Access Compliance Report

Public Rights-of-Way

(Curb Ramps)

Intersection ID: 20072	Main Street: AXIS_CT	Cross Street: FALLOW_LN	Location: NW
ADA ID: 687AC88E1837	Ramp Type: BlendTrans1	Initial Pass/Fail: Pass	Overall Compliance: No
Severity Score: 2.75			
Codes/Mitigation Info/Possible Solution		Field Measurements/Component Compliance

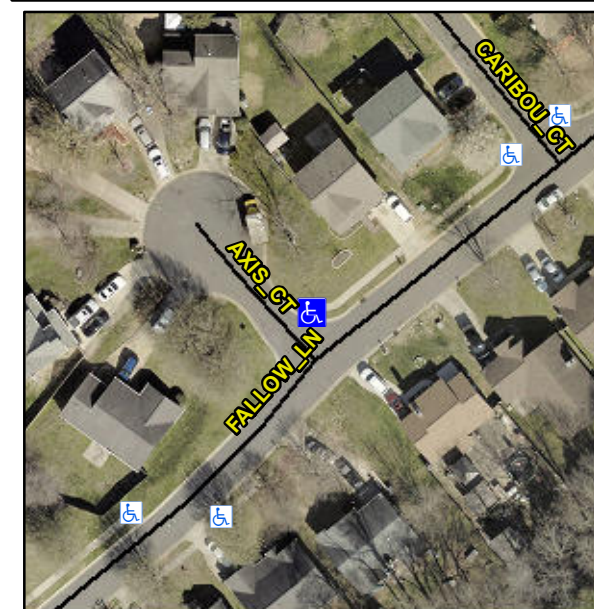
Not Found, R304.5.3, R304.2.1, R305.1.4, R305.2

Compliance	Description	Data	Compliance	Description	Data
N/A	Ramp Length (in)	64.0	Yes	BlendTrans Slope (%)	3.1
Yes	Ramp Width (in)	74.0	No	BlendTrans XSlope (%)	2.1
N/A	Flare Type LT	Sloped	N/A	Flare Type RT	Sloped
N/A	Flare Slope LT (%)	0.0	N/A	Flare Slope RT (%)	3.5
N/A	Flare Traversable LT?	No	N/A	Flare Traversable RT?	No
No	Landing Length (in)	36.0	Yes	DWS Provided?	Yes
Yes	Landing Width (in)	48.0	Yes	DWS Contrast?	Yes
Yes	Landing Slope (%)	1.1	Yes	DWS Length (in)	24.0
Yes	Landing X Slope (%)	1.1	No	DWS Full Width?	No
N/A	Landing Curb? (Y/N)	No	No	DWS Offset (in)	3.5
N/A	Shared Landing?	No			
Yes	Gutter Ponding?	No	Yes	Gutter Slope (%)	0.4
Yes	Gutter Lip Ht (in)	0.0	Yes	Gutter X Slope (%)	1.1
N/A	Painted X Walk1?	No	N/A	Painted X Walk2?	No
	X Walk 1 Direction	To SW		X Walk 2 Direction	To SE
	X Walk 1 Width (in)	N/A		X Walk 2 Width (in)	N/A
	X Walk 1 Slope (%)	3.7		X Walk 2 Slope (%)	3.8
	X Walk 1 X Slope (%)	2.1		X Walk 2 X Slope (%)	3.2

N/A	Ramp inside XWalk1?	N/A	N/A	Ramp inside XWalk2?	N/A
	Road Slope (%)	0.8		Clear Space?	Yes
	Road X Slope (%)	4.1	N/A	Clear Space to XWalk (in)	N/A
Yes	Any Obstructions?	No	Yes	Storm Grate/Utility Hazard?	No
	Obstruction Type			Storm Grate/Utility Type	
		N/A			N/A
			Yes	Surface Condition? (G/P)	Good
			No	Curb Slope (%)	12.0

Remove & Replace Curb Ramp With Two New Directional Ramps or Equivalent.
